**Michael A. Woodbury
Consulting Arborist**

August 2, 2016

Re: Arborist Review Tree Permit #2016-ARP-0024, Review and Recommendations
Site: Laboussiere property, 30XX 195th St. (parcel #615290-0033), Lake Forest Park, WA 98155.

Appendix B: 2012 AERIAL SITE PHOTO
Parcel #615290-0033
30XX NE 195th Street
Lake Forest Park, WA

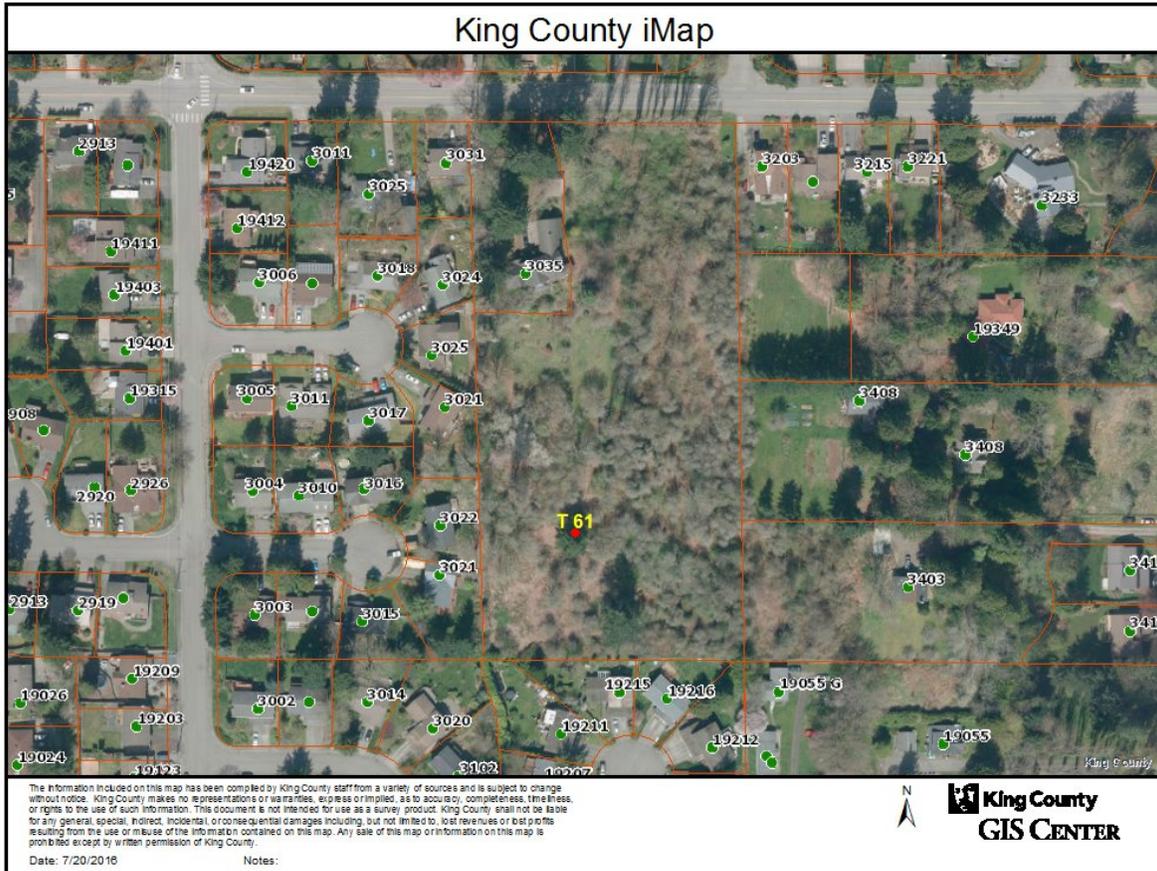
I identified an exceptionable Douglas-fir (Tree # 61) located within the buildable area(see Appendix B: *2012 Aerial Site Photo* for the tree location). The tree has the potential to tolerate construction impacts if the site plans can be designed to accommodate the tree. The tree could be an asset to the finished project and it is worthy of the energy and expense to retain it, if possible.

Location of Tree 61 a 24"DBH Douglas-fir.
